SUBJECT: Potential decreased service life of Slick 4-cylinder magneto distributor gear assemblies. Based on process and component improvements following the initial release of this service bulletin, the serial number range is being extended since the initial release.

ISSUED			REVISED			Champion Aerospace LLC 1230 Old Norris Road Liberty, SC/USA 29657 ©2021 Champion Aerospace LLC	PAGE NO.	REVISION
MO	DAY	YR	MO	DAY	YR			
07	02	15	12	28	21

Figure 5. K3008 Distributor Gear With Monel Electrode

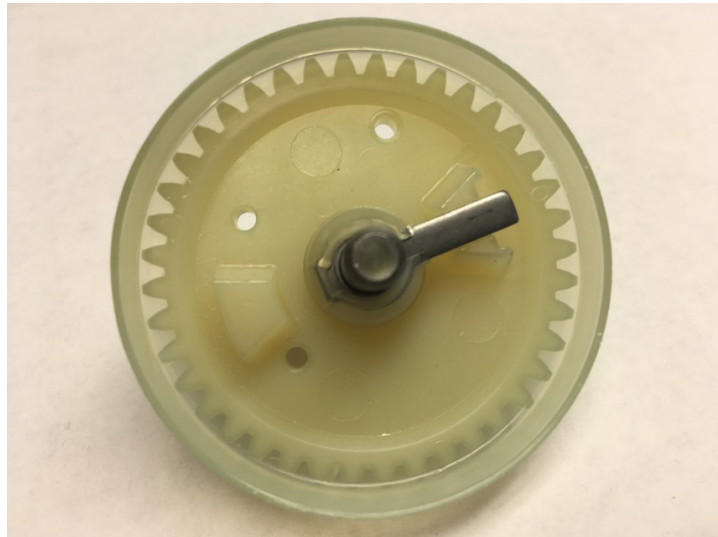
While the subject magneto distributor gear assemblies met all acceptance criteria at the time of production, the previous Service Bulletin was issued in order to eliminate any affected 4-cylinder magneto distributor gear assemblies (see below: MAINTENANCE PARTS AFFECTED). Champion Aerospace improved the new replacement K3008 distributor gear assembly to address this issue. Champion Aerospace has made further improvements to the K3008 distributor gear assembly with the final change being the change from a Copper to a Monel distributor gear electrode as of August 2016, making the ultimate product more robust.

If it is not possible to confirm the version of the distributor gear that is installed in a given magneto from maintenance records, the magneto may be removed from the engine in order to have the housing and distributor block removed to allow visual inspection of the distributor gear. Distributor gears with Copper electrodes must be replaced with distributor gears with Monel electrodes.
